Number	P.1
Section	Electrical and Instruments
Sheet	1 (of 1)
Date	January, 1960

INSTRUMENTS, OVERDRIVE AND AUTOMATIC  
TRANSMISSION INDICATOR LIGHTS

Number	P.2
Section	Electrical and Instruments
Sheet	1 (of 1)
Date	January, 1960

DRAIN HOLES IN NEW TYPE REAR LAMPS

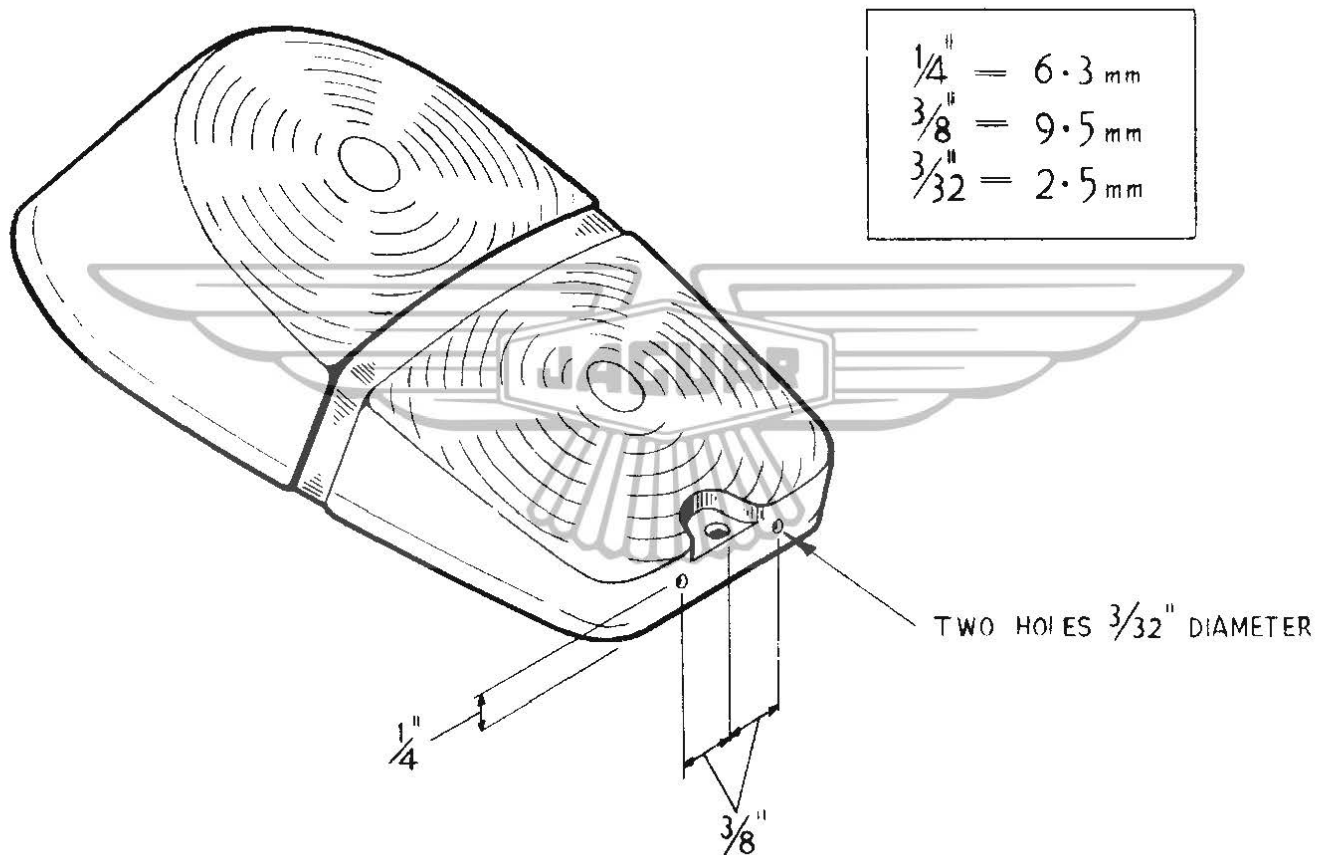
A certain number of 1960 cars with the new type rear lamps (with separate flasher and tail light bulbs) were sent out of the factory without the drain holes in the bottom of the lamp lens.

Cars in stock or cars coming in for servicing should be checked for having two holes drilled in the bottom of the rear lamp lens. If not so drilled, two holes should be made in the bottom of the lens as shown in the sketch overleaf.

FIG 2

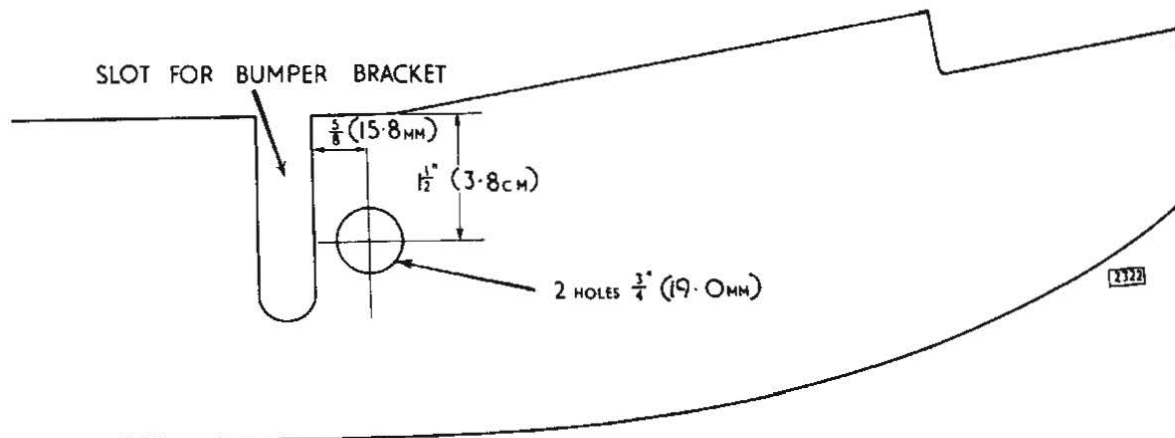
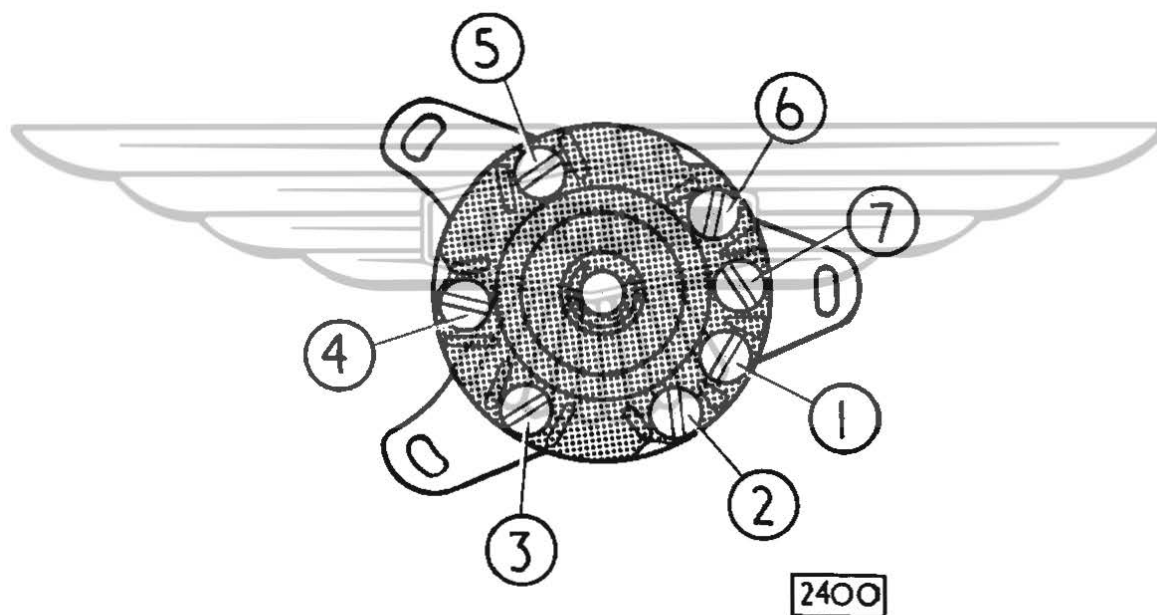
Remove the printed circuit resistance from the original switch (terminals 2 and 11) and refit to the new switch (terminal 2 - 4)

Replace the cables as shown in Fig.2. and connect the red/yellow cables, incorporated in the harness, to the foglamp terminal.

## MK 2 MODELS

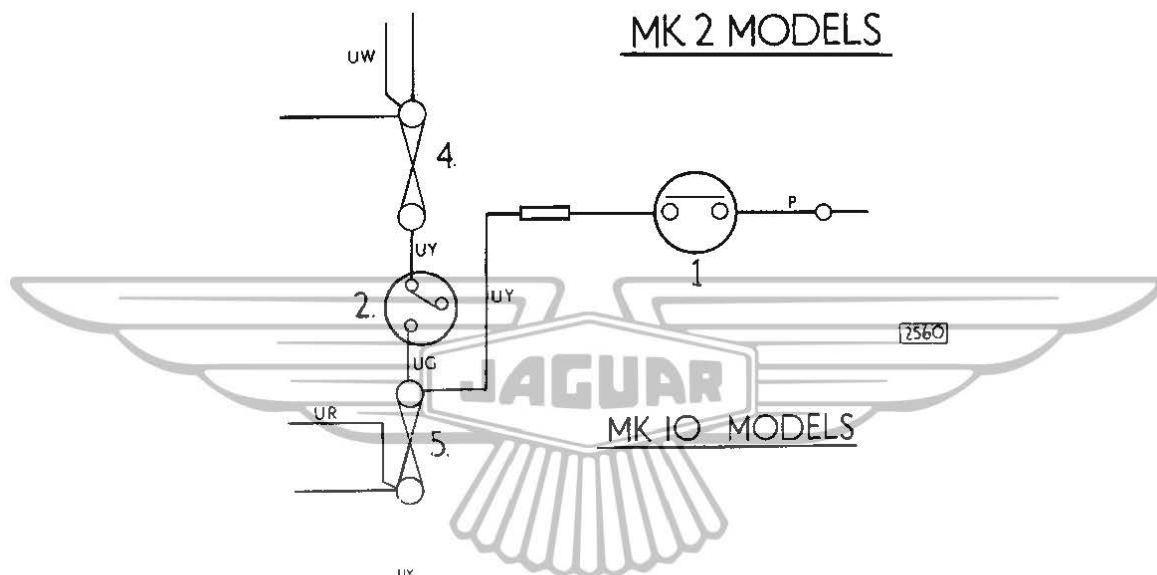
The amended wiring circuits are shown overleaf.

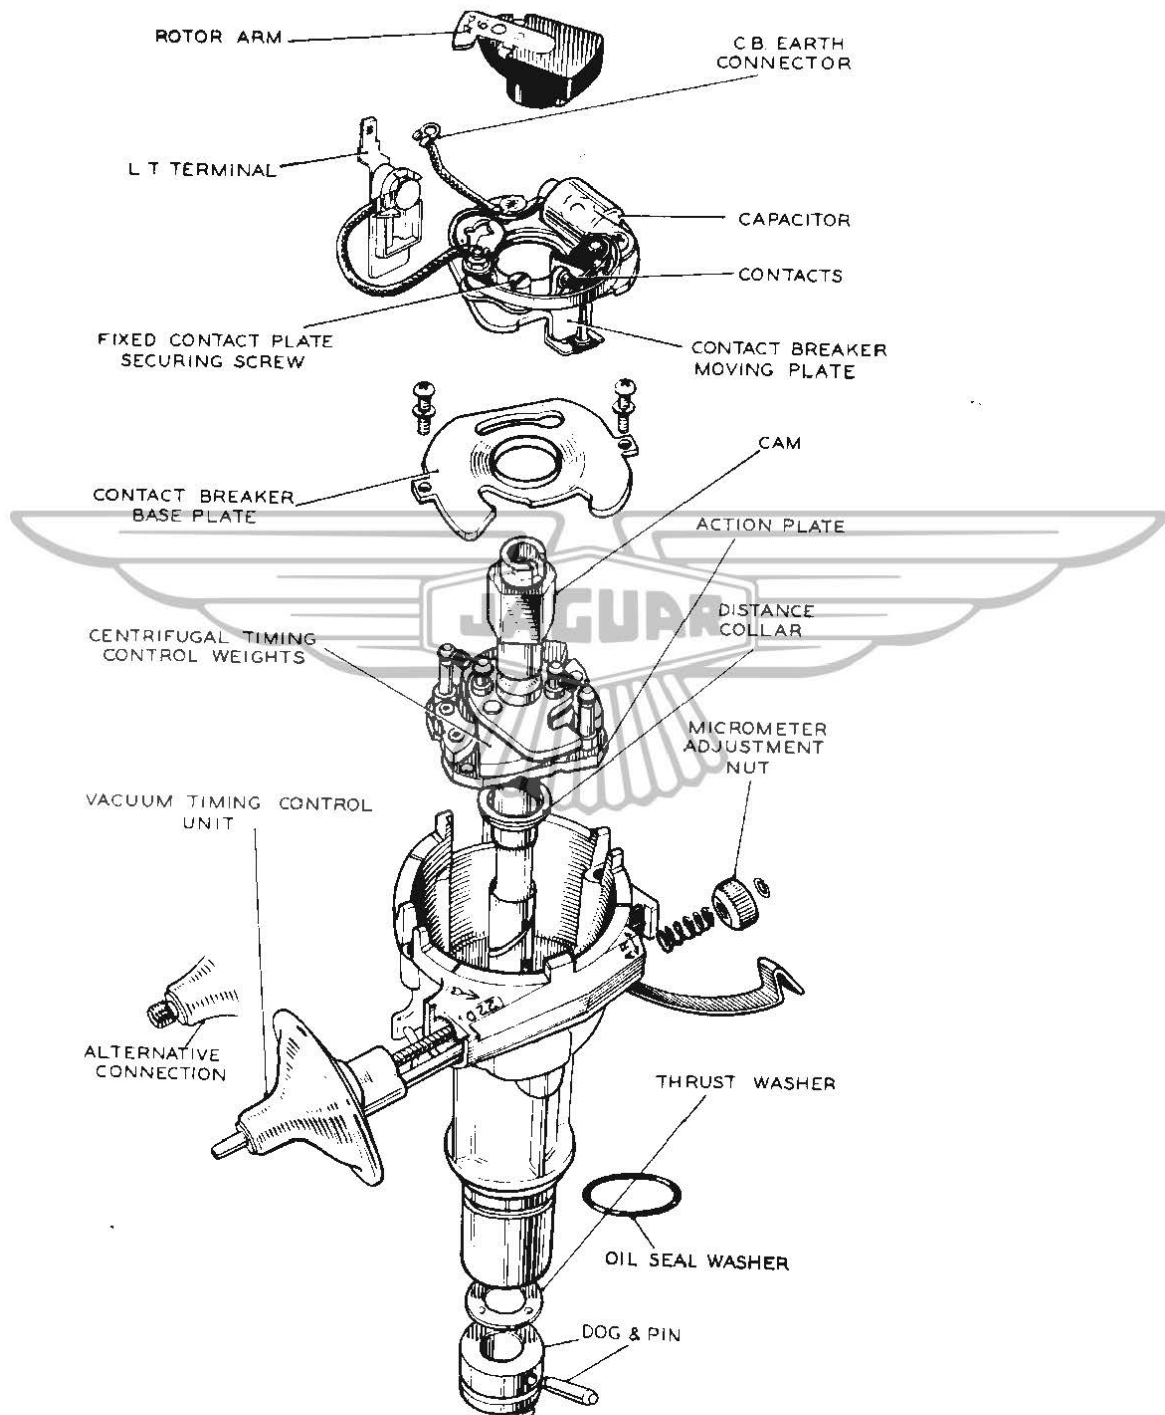
All current production cars are now fitted with a new 22D6 type distributor. (illustrated overleaf)

This type of distributor is different in construction to the previous DMBZ6 type fitted but the advance curves remain the same.

The new type distributors are interchangeable with their appropriate predecessors provided a new type suction pipe is fitted.

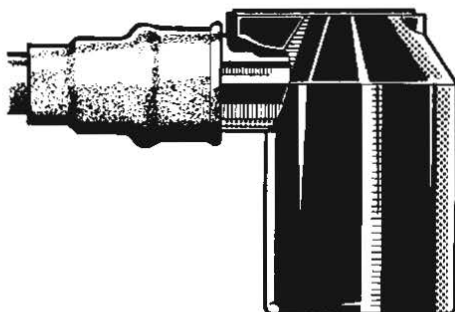
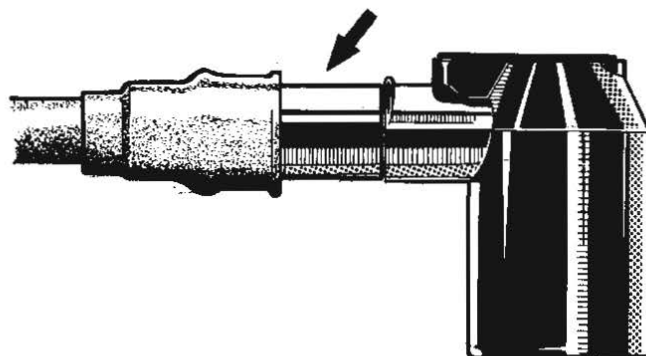
Fig.1 shows a sparking plug terminal without a suppressor fitted. Fig.2 shows the sparking plug terminal with suppressor fitted.

Distributors and dealers are requested to examine all cars coming in for service and check if suppressors are fitted. If suppressors are not fitted on cars within the guarantee period these must be fitted on a f.o.c basis to the customer.

Supplies may be obtained from the Jaguar Spares Division under Part number C.16979 (6 off) and a guarantee claim submitted quoting all relevant details. The time required for this work is negligible but a maximum allowance of  $\frac{1}{4}$  hour will be made should this be considered necessary.

### IGNITION SWITCH - AIR CONDITIONED CARS

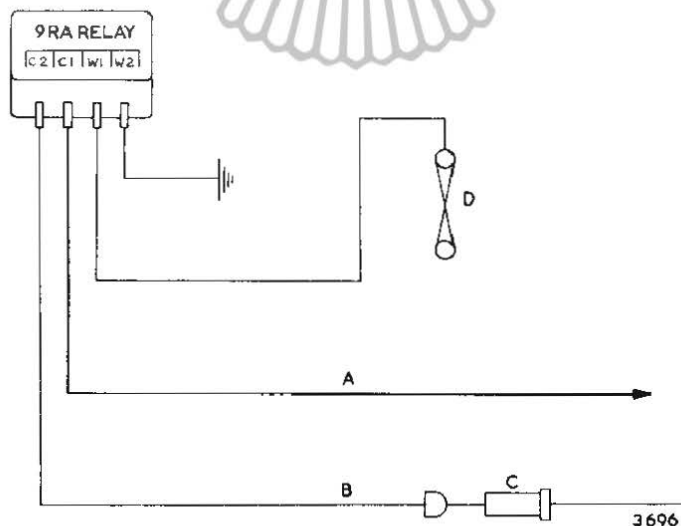
Isolated instances have occurred of ignition switch failure on cars fitted with an Air Conditioning System.

To prevent this fault recurring, a Lucas 9 RA Relay (Part No. C.19085) has been introduced into the Air Conditioning Electrical circuit on current production cars, the revised circuit being as illustrated.

If complaints are received of ignition switch failure, it is recommended that the relay is fitted in a convenient position and the circuit modified. The main output terminal (A) should have a 35 amp terminal fitted to connect to the alternator.
